## **Preliminary Report on Metrolink Route and its Potential Effect on the Cadenza Building**

**Waterman Moylan Consulting Engineers Limited**

**Client Name:** Irish Life Assurance plc.  
**Document Reference:** 18-020r.101  
**Project Number:** 18-020

Figure 10 Imposed Vertical Loadings - Bored Tunnel

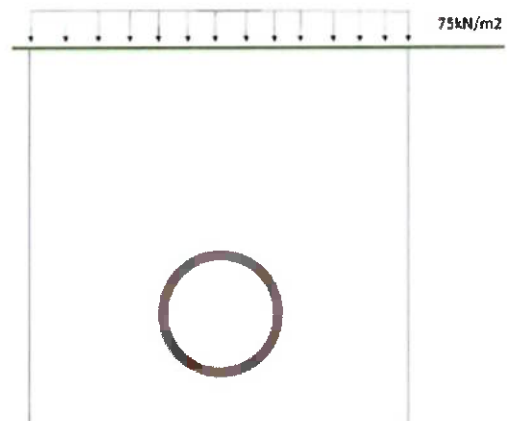
If this level of load limiting is imposed due to the Metrolink Tunnel, it would not be possible to build a traditional house, let alone rebuild the Cadenza Building, which imposes 1000kN/m<sup>2</sup> at the underside of the foundation level directly above the tunnel.

The conditions being imposed by the Metrolink Tunnel would preclude either the vertical extension or the demolition and redevelopment of the Cadenza Building, and the exclusion zone would also appear to preclude the deepening of the existing basement level.

**A. Jacob / IDOM drawing number ML1-JAI-EAI-ROUT\_XX-DR-Y-21146**

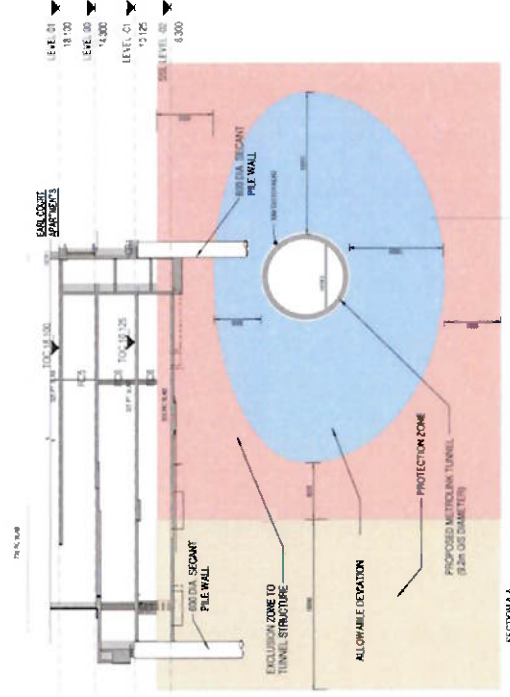
Jacob / IDOM drawing number ML1-JAI-EAI-ROUT\_XX-DR-Y-21146, revision P02 dated 23 February 2024 (which appears to supersede ML1-JAI-EAI-ROUT\_XX-DR-Y-21149 revision P02, which was included in Appendix C of the BDR), indicates the Jacob / IDOM engineers predict subsidence/settlement of up to 30mm under the footprint of the Cadenza Building. A copy of Jacob / IDOM, drawing number ML1-JAI-EAI-ROUT\_XX-DR-Y-21146 Rev P02, has been included in Appendix A of this Report for ease of reference.

The magnitude of the subsidence/settlement under the Cadenza Building is not uniform and varies from 0mm to 30mm. The maximum subsidence/settlement is experienced directly under one of the main stair cores, which provides stability to the building.

The settlement contours presented by Jacob / IDOM indicate that differential settlement/distortion of the Cadenza Building is going to occur, resulting in the following damage:

**C. Waterman Moylan Drawing Number EARL-WMS-ZZ-ZZ-DR-S-21300**

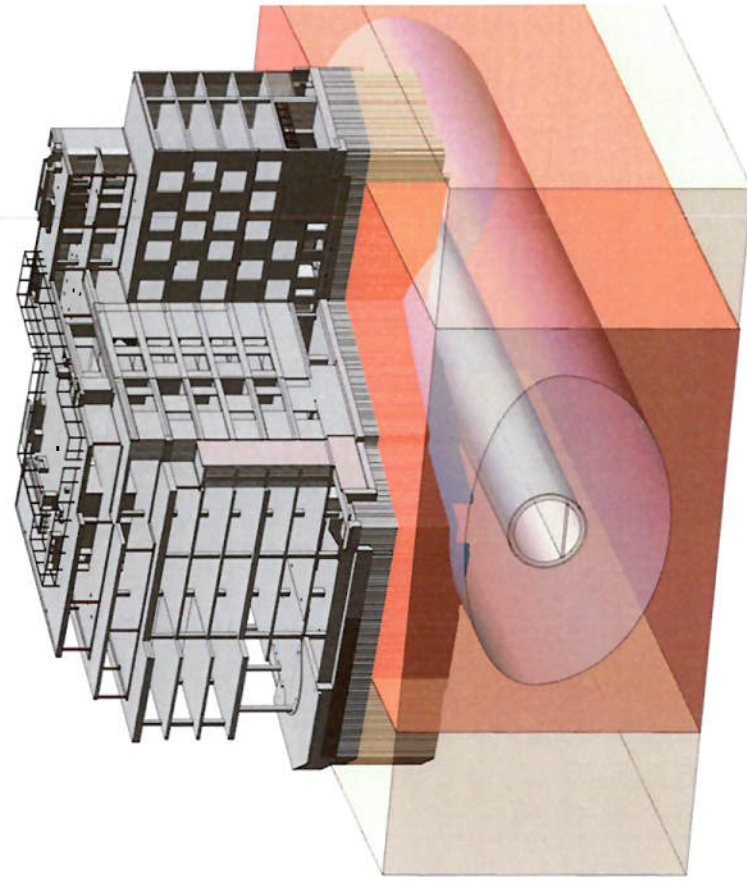
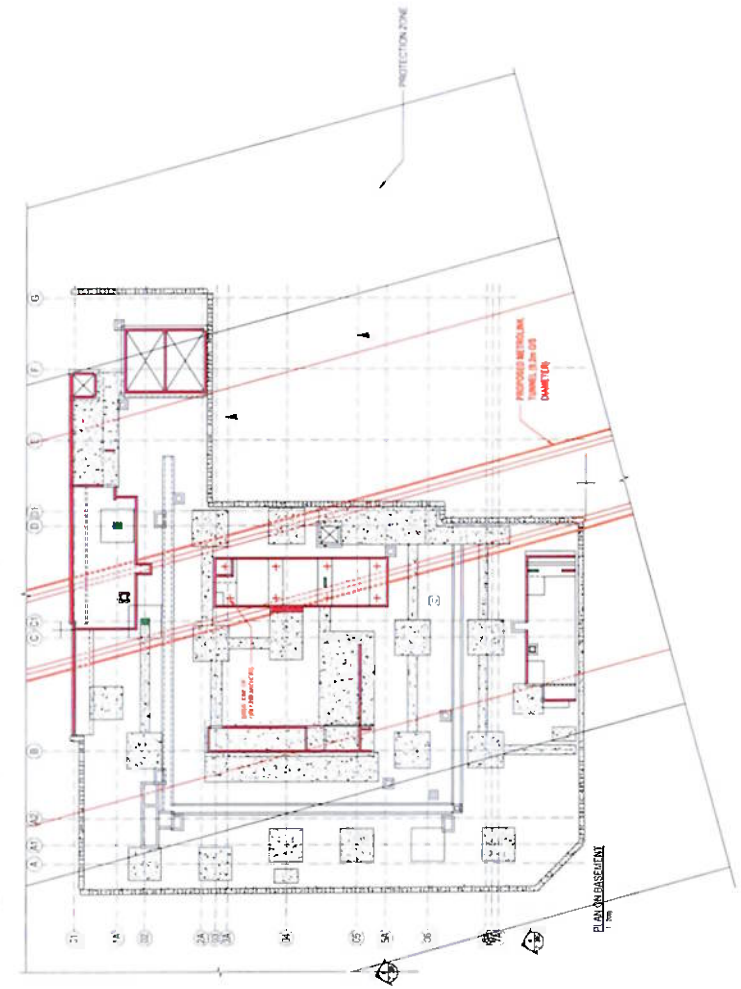
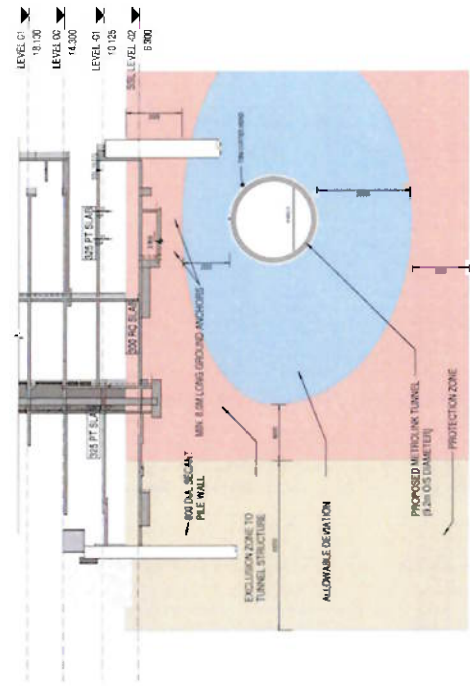
We have included drawing number EARL-WMS-ZZ-ZZ-DR-S-21300 in Appendix C of this Report, which indicates the existing structure of the Cadenza Building overlaid with the proposed Metrolink tunnel route and the tunnel exclusion zones set out in the Draft Guidance Note For Developers document.

It is clear to see that the exclusion zones presented in the Draft Guidance Note For Developers document were not developed with consideration for the existing Cadenza Building, as the lower basement substructure is located within the proposed exclusion zone.

**D. Waterman Moylan Drawing Number EARL-WMS-ZZ-ZZ-DR-S-21301**

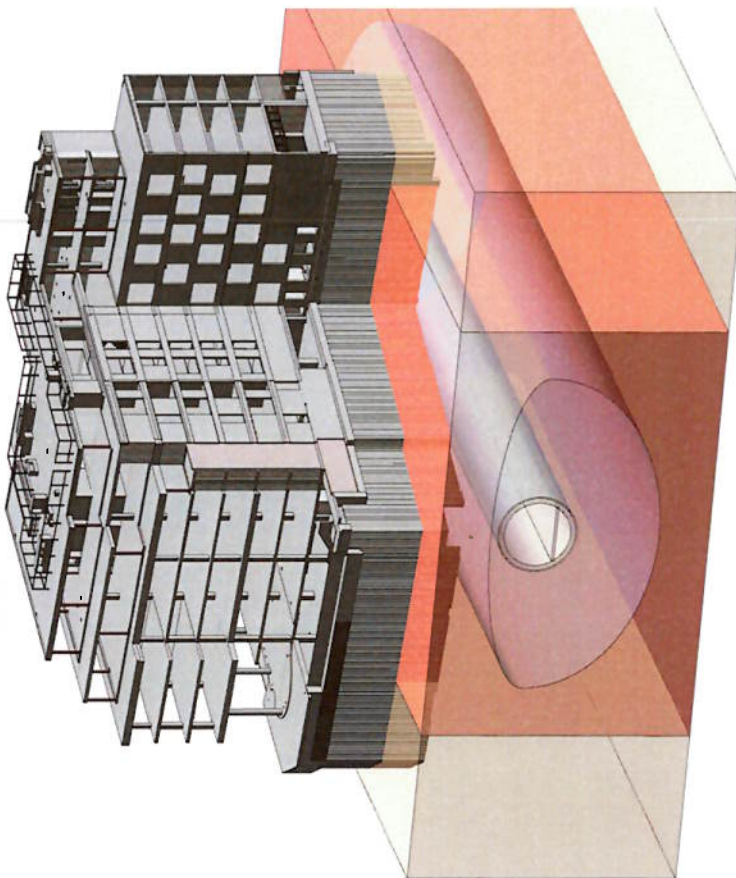
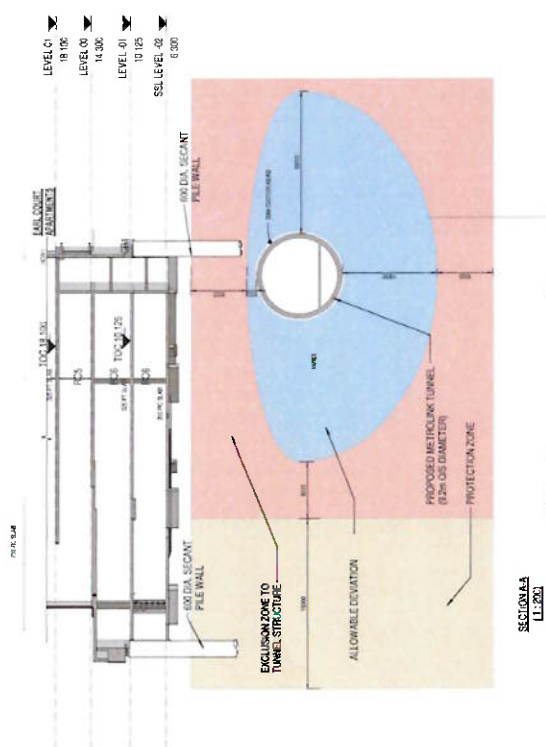
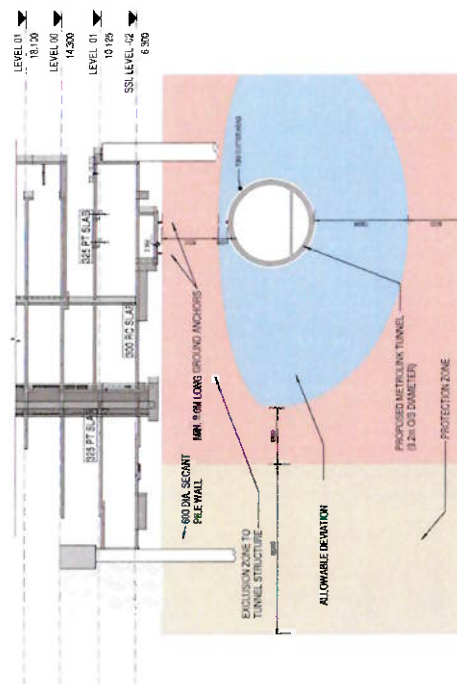
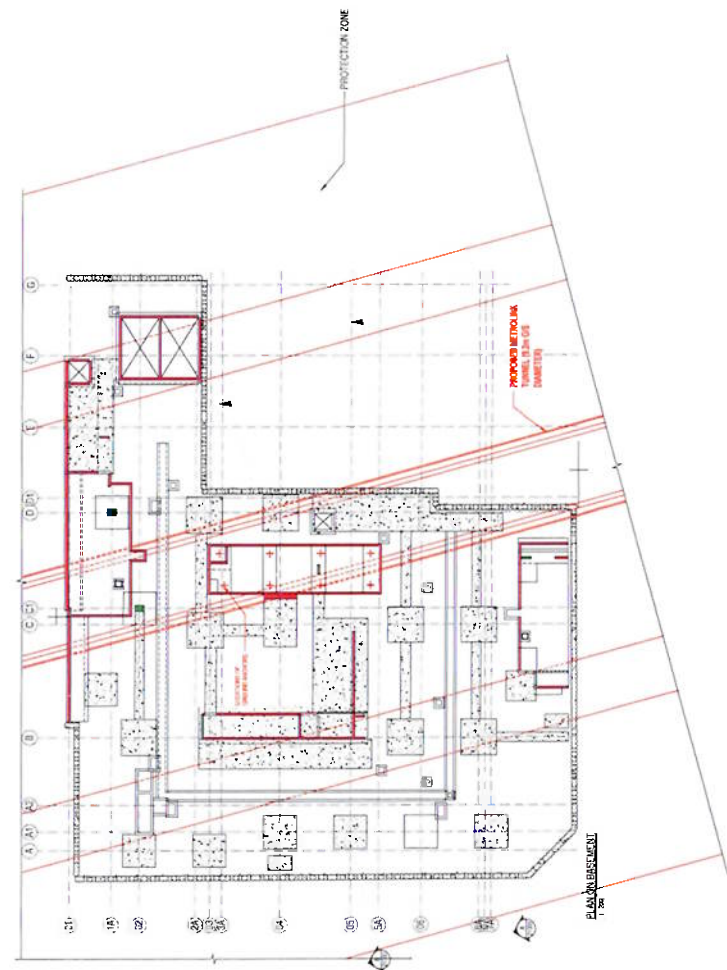
We have also included drawing number EARL-WMS-ZZ-ZZ-DR-S-21301 in Appendix D of this Report, which indicates the existing structure of the Cadenza Building overlaid with the proposed Metrolink tunnel route and the reduced tunnel exclusion zones set out in document DOC ML1-JAI-GEO-ROUT\_XX-RP-Y-00034.

Based on the findings of drawing number EARL-WMS-ZZ-ZZ-DR-S-21301, it is clear to see that both the tension anchors to the attenuation tank and the secant piled wall to the basement still extend into the exclusion zone.

The tension anchors clash with the location of the proposed tunnel. Based on our assessment of the existing structure versus the proposed Metrolink alignment, the TBM is going to cut through the bottom 1.0m of the existing tension anchors. Any damage to the tension anchors or the secant piled wall is going to result in damage to the basement structure and the integrated basement waterproofing system provided through the Whitetank waterproofing system.

Based on the geometrical findings of drawing number EARL-WMS-ZZ-ZZ-DR-S-21301, we believe that :

- a) The route of the Metrolink Tunnel should be diverted to avoid clashing with the existing substructure of the Cadenza Building and damaging the existing building or
- b) The elevation of the Metrolink Tunnel should be significantly lowered to the extent necessary to ensure that no damage will be caused to any part of the Cadenza Building.
